CITY OF PALO ALTO
Architectural Review Board
Regular Meeting
Thursday, May 02, 2024
8:30 AM

3. Study Session to provide feedback on the Pre-Approved Parklet Designs and the Associated Draft User Guide.

PALO ALTO ONGOINGPERMANENT PARKLETS PROGRAM

(Proposed modifications to the adopted standard)

FIGURE 3: Dimensions of an Angled Parking Space Parklet

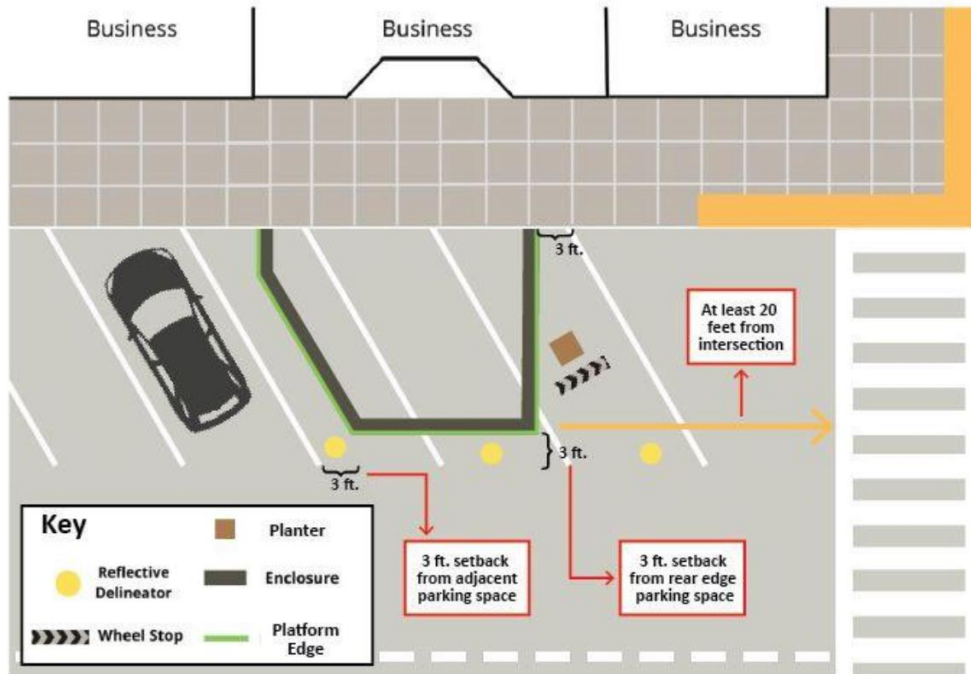
- i. The setback between two adjacent parallel space parklets shall be 8 feet (two 4-foot setbacks).
- b. As stated above, all parklets in angled parking spaces must be setback 3 feet from adjacent parking spaces and 3 feet from the rear edge of the parking space (see figure 3).

- i. The setback between two adjacent angled space parklets shall be 8-6 feet (two 4-3-foot setbacks).
- c. All parklets are required to include 15-foot setback from adjacent driveways, as measured from the highest point of the curb cut (i.e., the top of the adjacent driveway wing).
